SUBJECT: ISSUANCE OF AMENDMENTS (TAC NOS. 71488 AND 71489)

Amendment No. 114
License No. DPR-19

Amendment No. 111
License No. DPR-25

SAFETY EVALUATION BY THE OFFICE OF NUCLEAR REACTOR REGULATION
RELATED TO AMENDMENT NO. 114 TO FACILITY OPERATING LICENSE NO. DPR-19
AND AMENDMENT NO. 111 TO FACILITY OPERATING LICENSE NO. DPR-25
COMMONWEALTH EDISON COMPANY
DRESDEN NUCLEAR POWER STATION, UNITS 2 AND 3
DOCKET NOS. 50-237 AND 50-249

FIGURE 3.6.1.

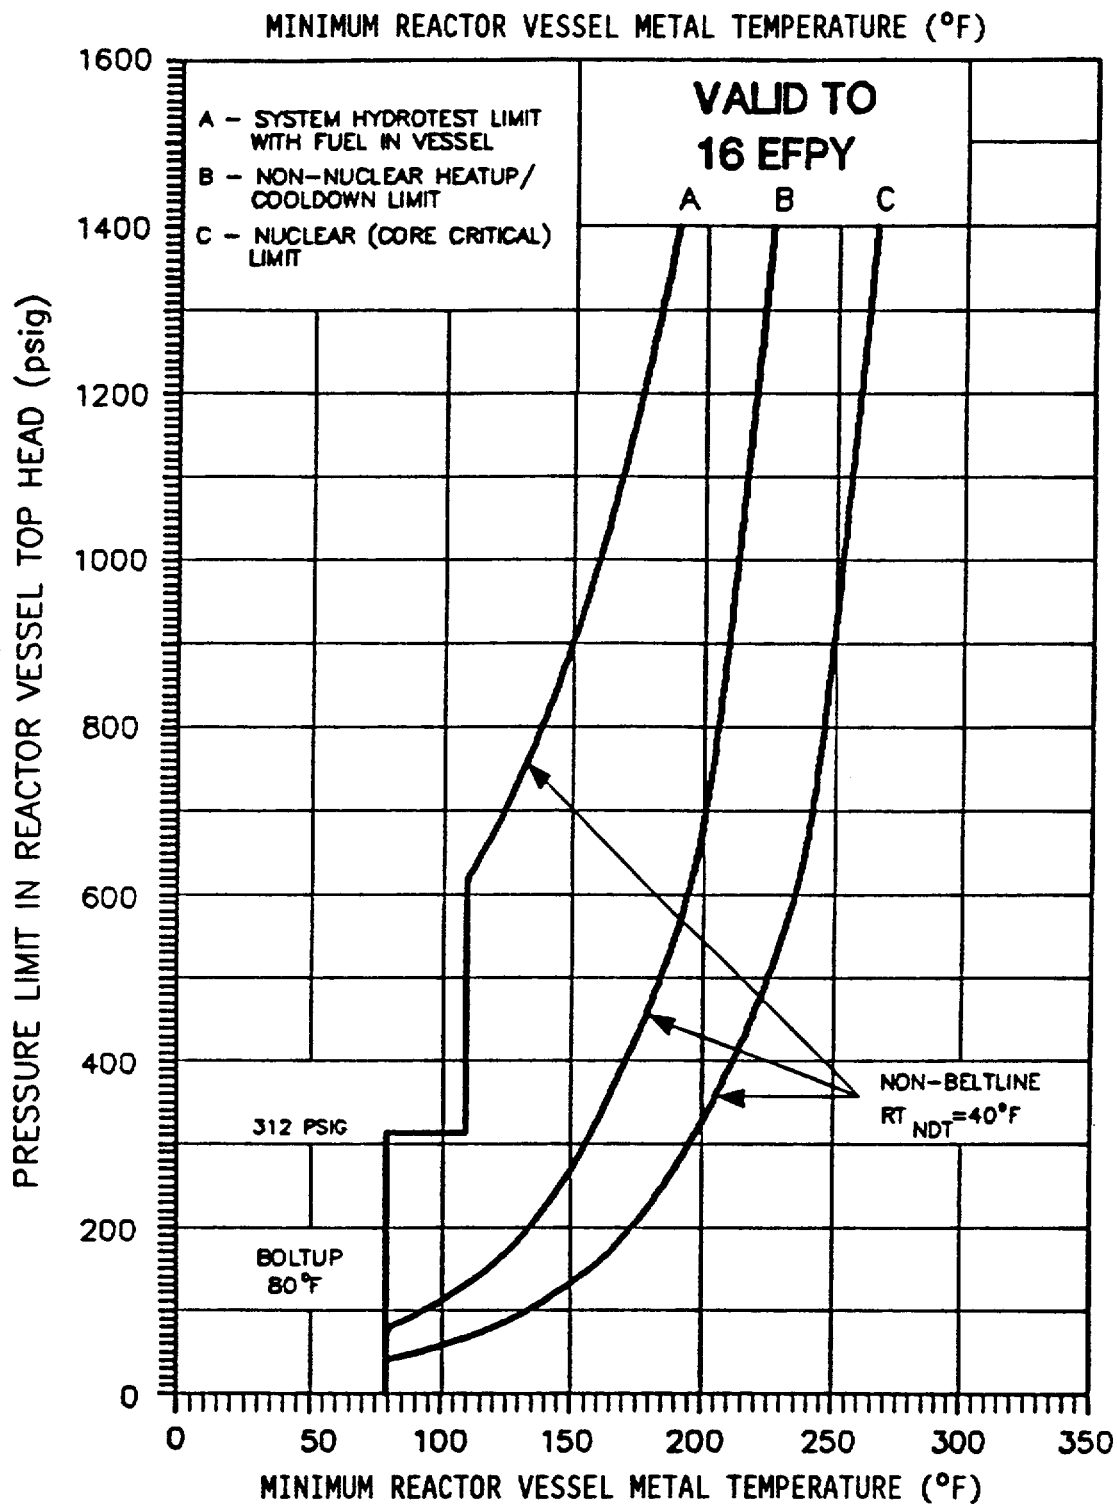
1. The reactor vessel shall be vented and power operation shall not be conducted unless the reactor vessel temperature is equal to or greater than that shown in Curve C of Figure 3.6.1. Operation for hydrostatic or leakage tests, during heatup or cooldown, and with the core critical shall be conducted only when reactor vessel metal temperature is equal to or above that shown in the appropriate curve of Figure 3.6.1. Figure 3.6.1 is effective through 16 effective full power years. At least six months prior to 16 effective full power years new curves will be submitted.
2. The reactor vessel head bolting studs shall not be under tension unless the temperature of the vessel shell immediately below the vessel flange is greater than or equal to 80°F.

As indicated in Curve A of Figure 3.6-1 for system hydrotesting, the minimum metal temperature of the reactor vessel shell is 80°F for reactor pressures less than 312 psig. This 80°F minimum boltup temperature is based on an RT_{NDT} of 20°F for the top head plate (most limiting material) and a 60°F conservatism required by the original ASME Code of construction.

At reactor pressures greater than 312 psig the minimum vessel metal temperature is established as 110°F. The 110°F minimum temperature is based on a closure flange region RT_{NDT} of 20°F and a 90°F conservatism required by 10 CFR 50 Appendix G for pressure in excess of 20% of the preservice hydrostatic test pressure (1563 psig).

At approximately 620 psig reactor pressure the effects of pressurization become more limiting than the boltup stresses at the closure flange region, as shown by the non-linear portion of Curve A intersecting the vertical 110°F line. The non-linear portion of the curve is dependent on the non-beltline region (which is actually more limiting than the beltline region through a vessel exposure of 22 effective full power years), and based on an RT_{NDT} of 40°F.

Curve B of Figure 3.6.1 applies during heatups with non-nuclear heat (e.g., recirculation pump heat) and during cooldowns when the reactor is not critical (e.g., following a scram). The curve provides the minimum reactor vessel metal temperatures based on the most limiting vessel stress (non-beltline stresses).

As indicated by the vertical 80°F line, the boltup stresses at the closure flange region are most limiting below approximately 80 psig. Above approximately 80 psig, pressurization and thermal stresses become more limiting than the boltup stresses, which is reflected by the non-linear portion of Curve B. The non-linear portion of the curve is dependent on non-beltline region (which is actually more limiting than the beltline region through a vessel exposure of 22 effective full power years), and based on an RT_{NDT} of 40°F.

Curve C, the core critical operation curve shown in Figure 3.6.1, is generated in accordance with 10 CFR 50 Appendix G which requires core critical pressure-temperature limits to be 40°F above any Curve A or B limits. Since Curve B is more limiting, Curve C is Curve B plus 40°F.

FIGURE 3.6.1.

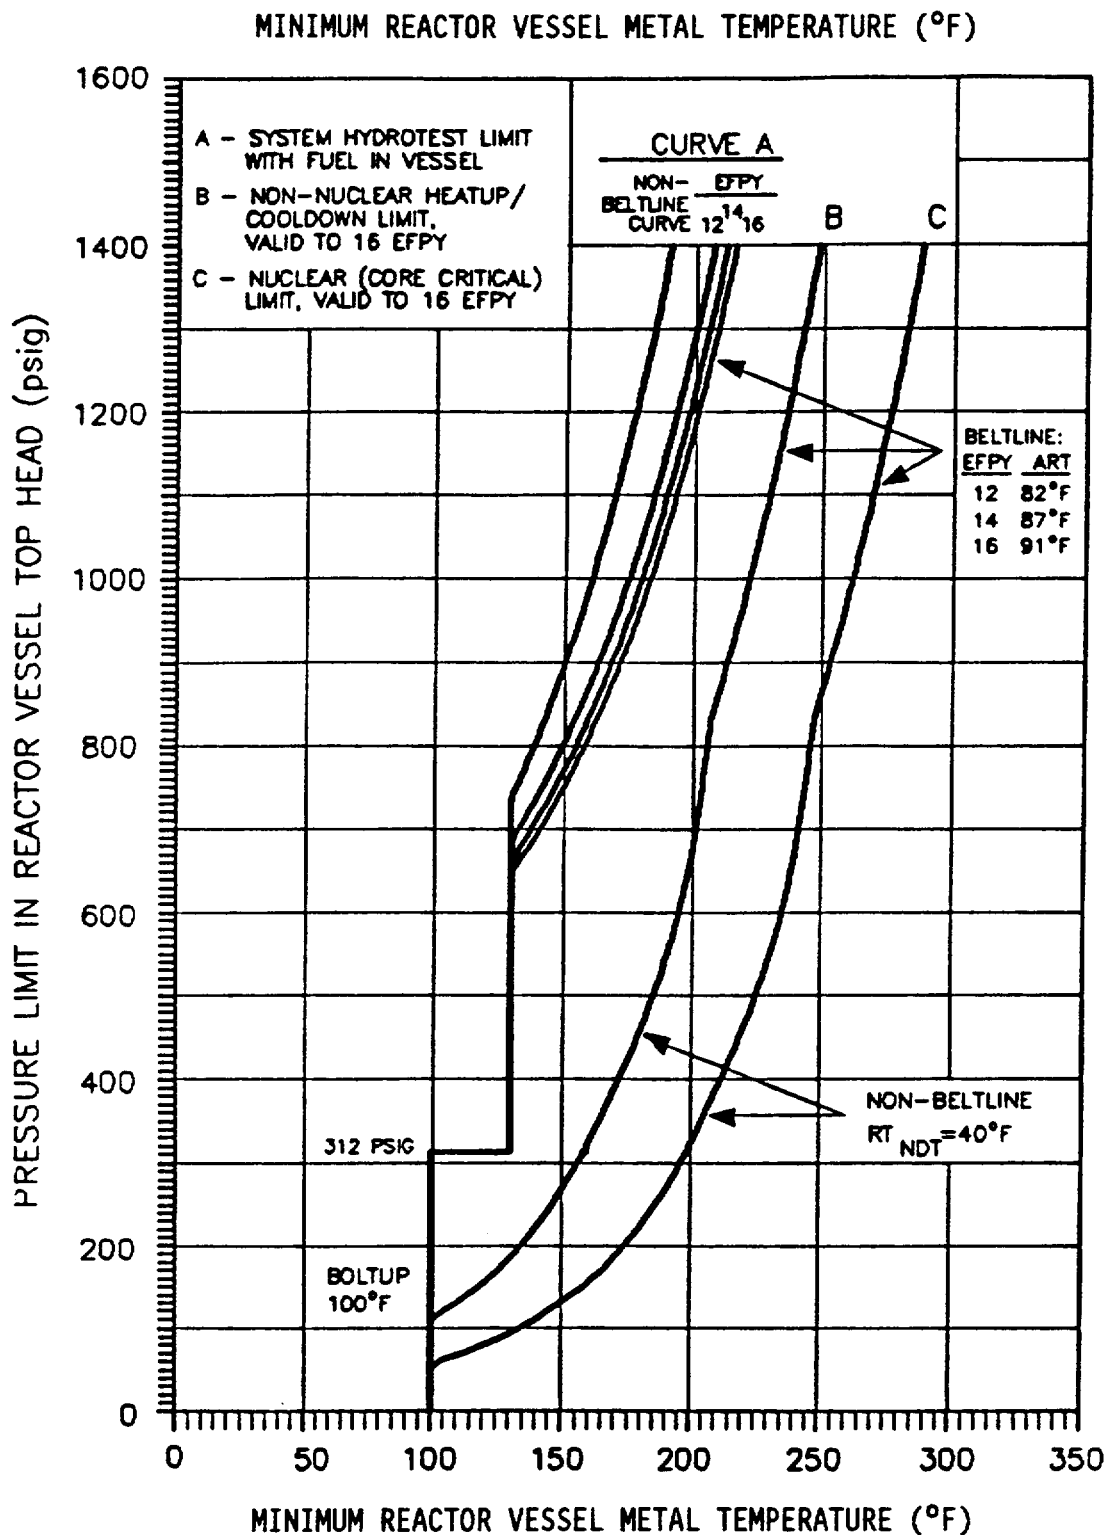
1. The reactor vessel shall be vented and power operation shall not be conducted unless the reactor vessel temperature is equal to or greater than that shown in Curve C of Figure 3.6.1. Operation for hydrostatic or leakage tests, during heatup or cooldown, and with the core critical shall be conducted only when reactor vessel metal temperature is equal to or above that shown in the appropriate curve of Figure 3.6.1. Figure 3.6.1 is effective through 16 effective full power years. At least six months prior to 16 effective full power years, new curves will be submitted.
2. The reactor vessel head bolting studs shall not be under tension unless the temperature of the vessel shell immediately below the vessel flange is greater than or equal to 100°F.

As indicated in Curve A of Figure 3.6.1 for system hydrotesting, the minimum metal temperature of the reactor vessel shell is 100°F for reactor pressures less than 312 psig. This 100°F minimum boltup temperature is based on an RT_{NDT} of 40°F for the electroslag weld immediately below the vessel flange and a 60°F conservatism required by the original ASME Code of construction.

At reactor pressures greater than 312 psig, the minimum vessel metal temperature is established as 130°F. The 130°F minimum temperature is based on a closure flange region RT_{NDT} of 40°F and a 90°F conservatism required by 10 CFR 50 Appendix G for pressure in excess of 20% of the preservice hydrostatic test pressure (1563 psig).

At approximately 650 psig the effects of pressurization are more limiting than the boltup stresses at the closure flange region, hence a family of non-linear curves intersect the 130°F vertical line. Beltline as well as non-beltline curves have been provided to allow separate monitoring of the two regions. Beltline curves as a function of vessel exposure for 12, 14 and 16 effective full power years (EFPY) are presented to allow the use of the appropriate curve up to 16 EFPY of operation.

Curve B of Figure 3.6.1 applies during heatups with non-nuclear heat (e.g., recirculation pump heat) and during cooldowns when the reactor is not critical (e.g., following a scram). The curve provides the minimum reactor vessel metal temperatures based on the most limiting vessel stress.

As indicated by the vertical 100°F line, the boltup stresses at the closure flange region are most limiting for reactor pressures below approximately 110 psig. For reactor pressures greater than approximately 110 psig, pressurization and thermal stresses become more limiting than the boltup stresses, which is reflected by the non-linear portion of Curve B. The non-linear portion of the curve is dependent on non-beltline and beltline regions, with the beltline region temperature limits having been adjusted to account for vessel irradiation (up to a vessel exposure of 16 EFPY). The non-beltline region is limiting between approximately 110 psig and 830 psig. Above approximately 830 psig, the beltline region becomes limiting.

Curve C, the core critical operation curve shown in Figure 3.6.1, is generated in accordance with 10 CFR 50 Appendix G which requires core critical pressure-temperature limits to be 40°F above any Curve A or B limits. Since Curve B is more limiting, Curve C is Curve B plus 40°F.
